**April 25, 2017**

**ADDENDUM NO. 1**

**Durham County Courthouse Security System  
RFP 17-031**

# Courthouse 10th Floor

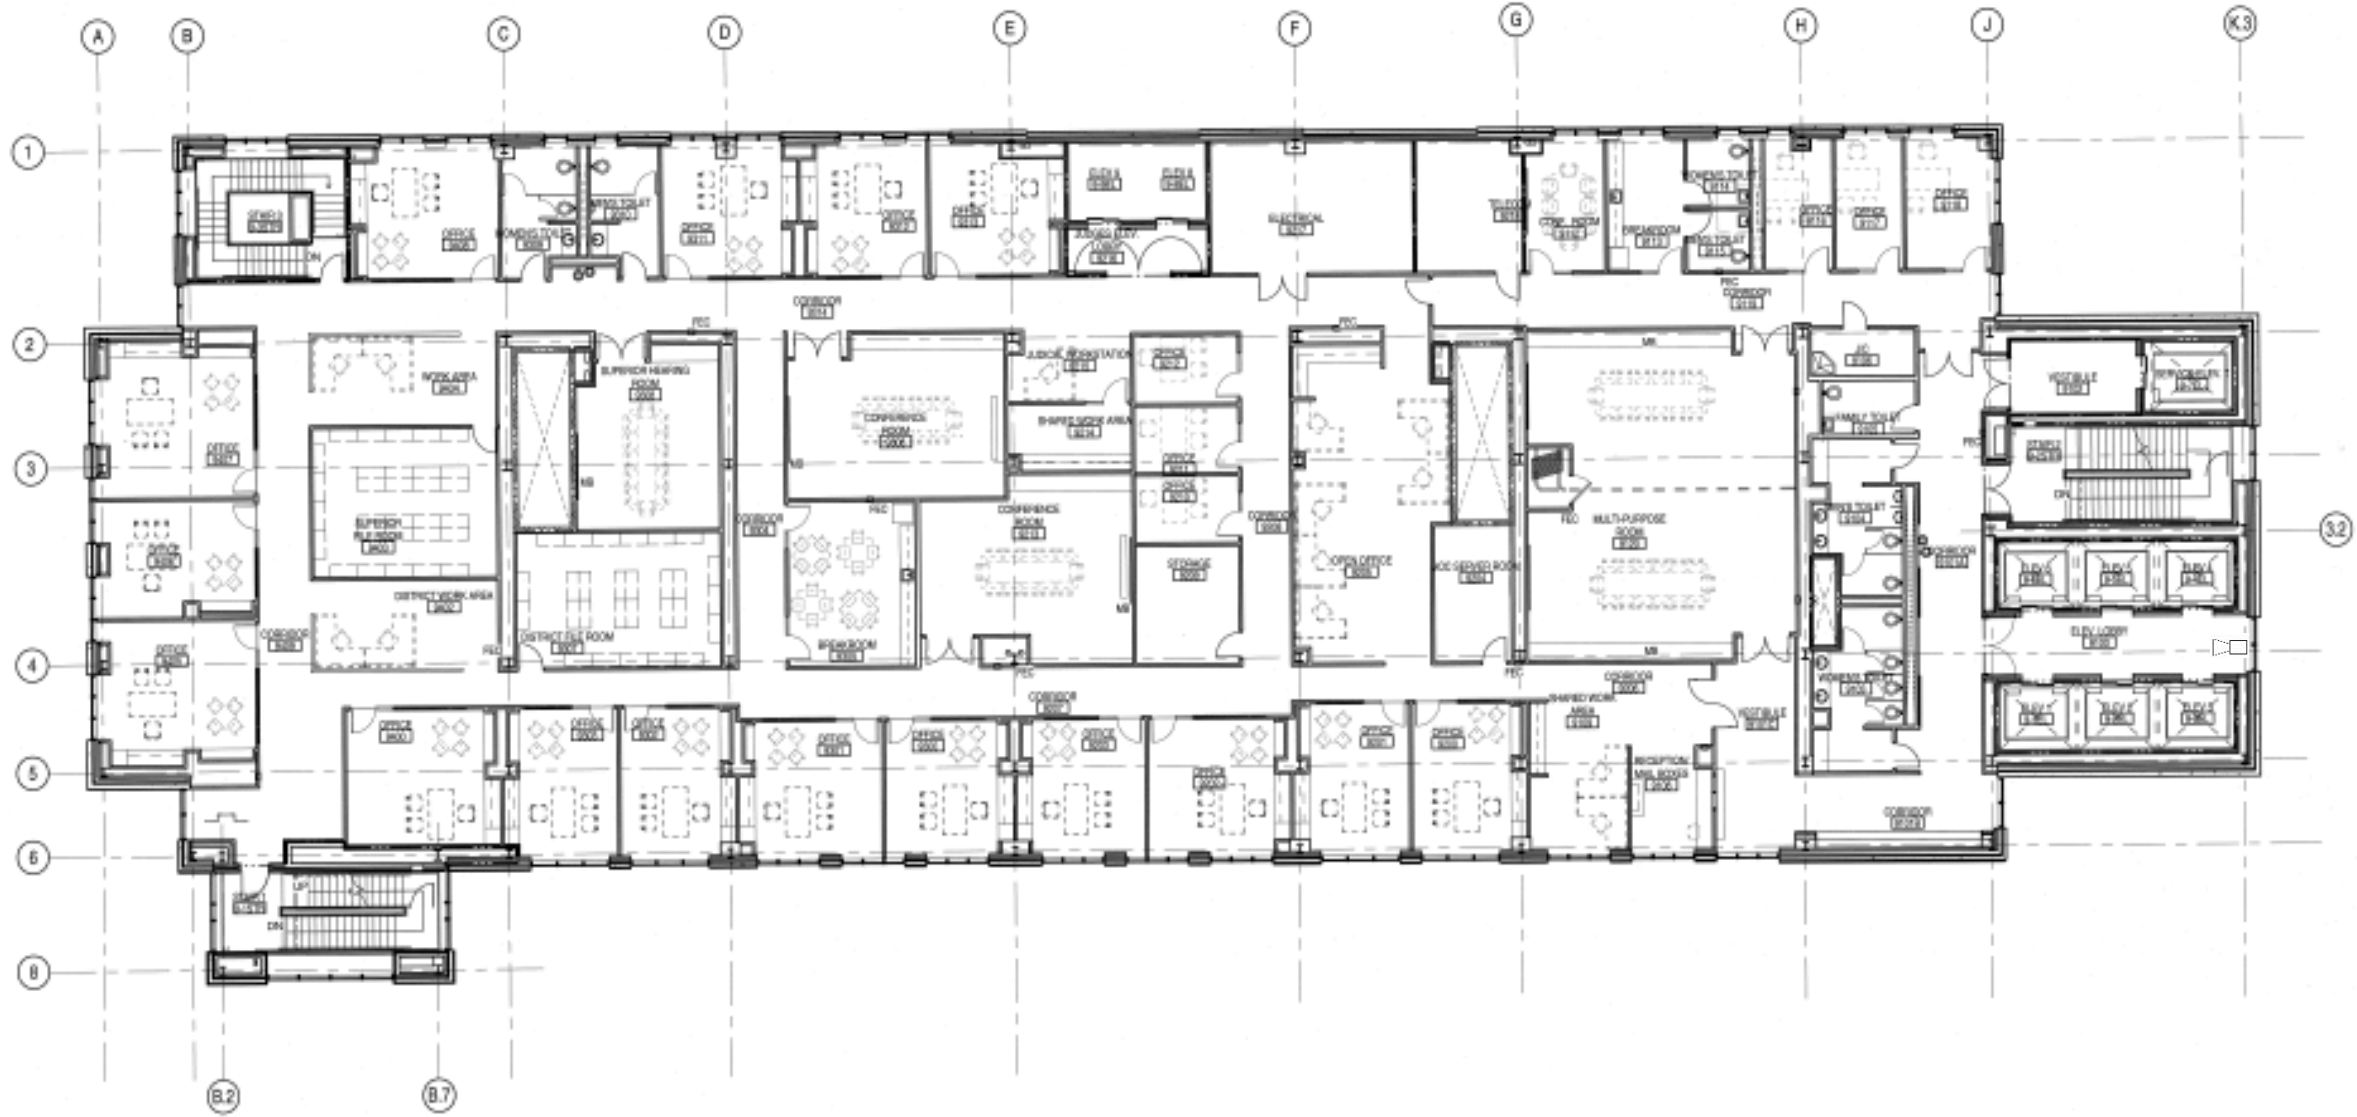
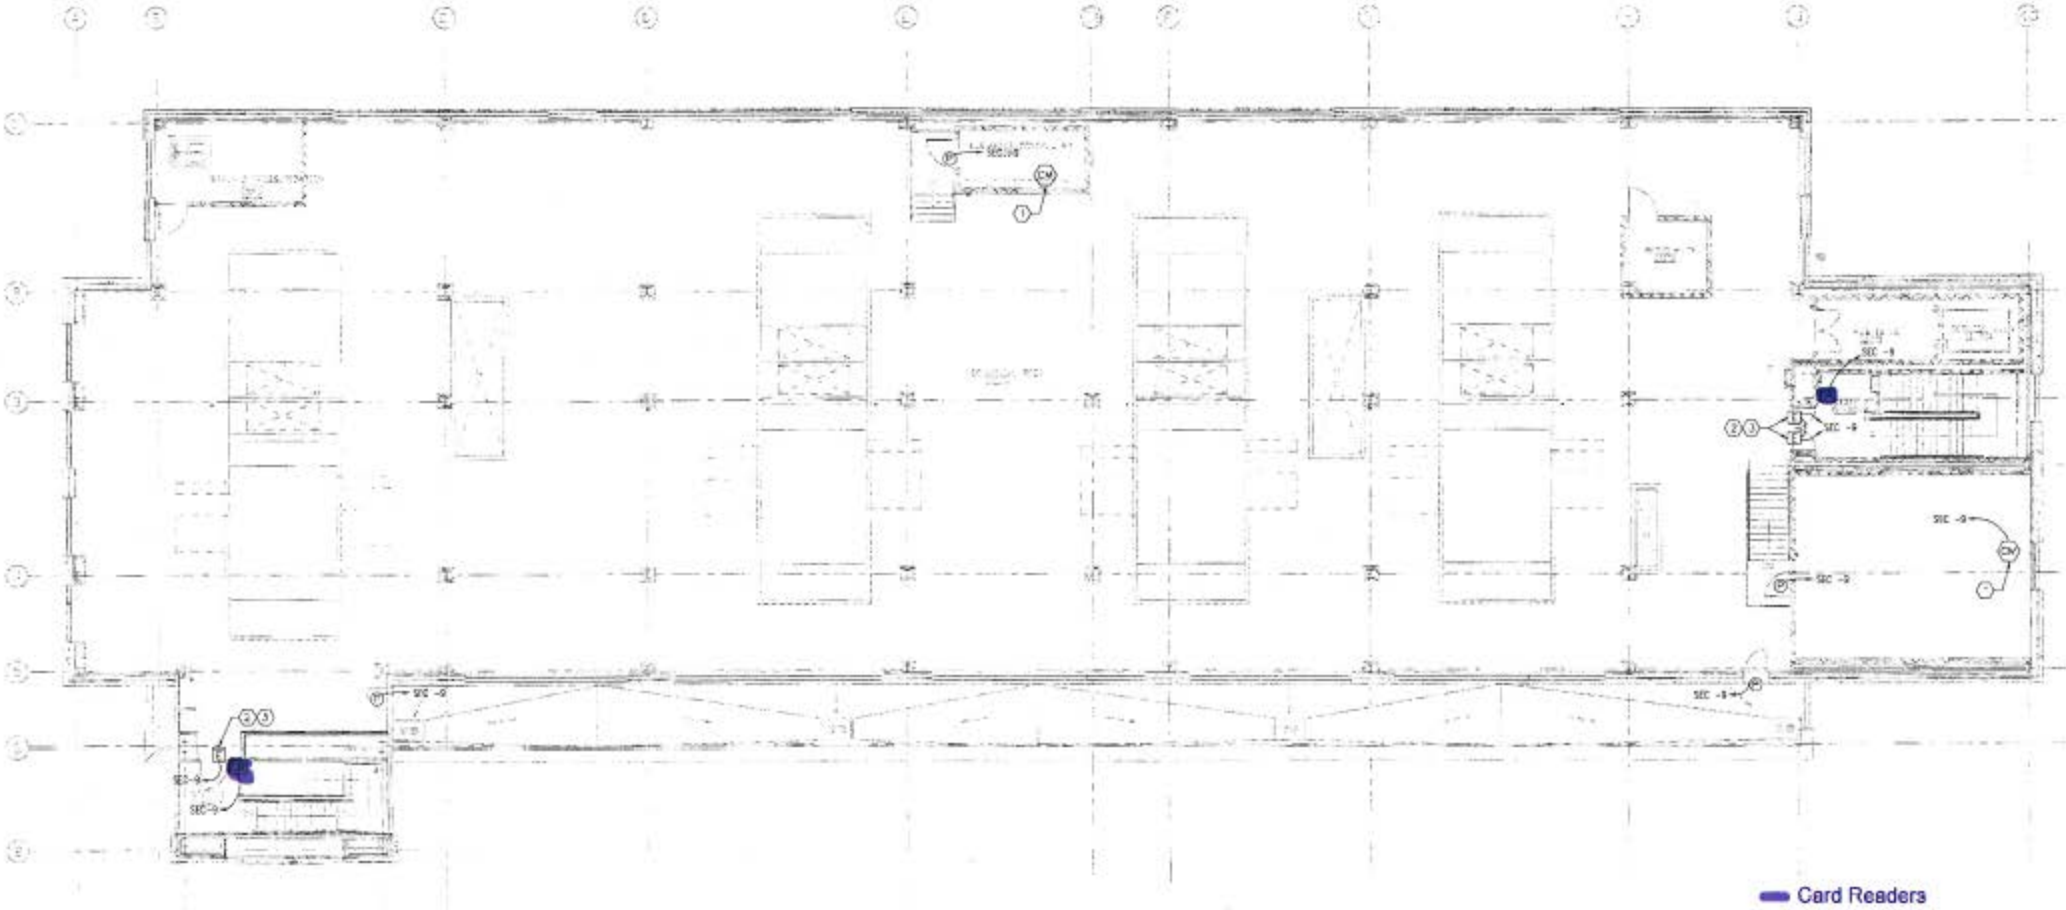
**Question 9** Are Maps required? If so, will CAD files be provided? Or will appropriate MAP files be provided?

**Question 27** Please provide a set of the PDF maps that are to be used in the system. This is to allow for estimating the amount of time to prepare the plans for importing into S2.

**Response** See Attachment 3 Durham County Courthouse Floor Plans

**Response** See Attachment 3, Durham County Courthouse Floor Plans
